McLaren 570S & 600LT – Fuel Hose Replacement; Fuel Tank to Engine

Bulletin type:	Service Campaign
Reference number:	SCB 13 K 001
Attention:	Retailer Service Managers and Retailer Technicians
Affected vehicles:	McLaren 570S and 600LT Coupe and Spider
Situation:	Fuel Hoses require replacement
Procedure:	To action affected vehicles during PDI or Prior to Sale / Handover. Please refer to the information outlined in this document to ensure replacement of the required fuel hoses is carried out
Date:	30 th January 2020

Layout overview – Fuel hoses to be replaced (1)
(extract from SCB 13 K 001 WI)

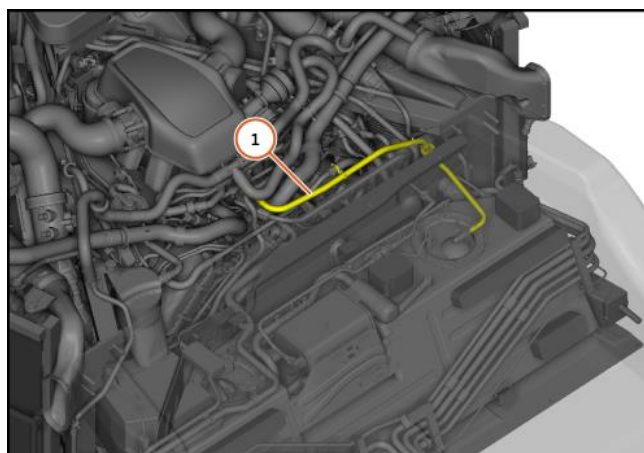
Through continuous product quality monitoring, it has been identified that a number of McLaren 570S and 600LT vehicles (Coupe and Spider versions) require two fuel hoses to be replaced during PDI or prior to sale/handover of the vehicle.

To carry out the required re-work, replace the specified fuel hoses.

The parts below are required to action this repair, which can be ordered via Unipart.

Part Number	Part Description	Quantity Required
13K0026CP	Fuel feed - Fuel tank	1
13K0027CP	Fuel feed - Engine bay	1
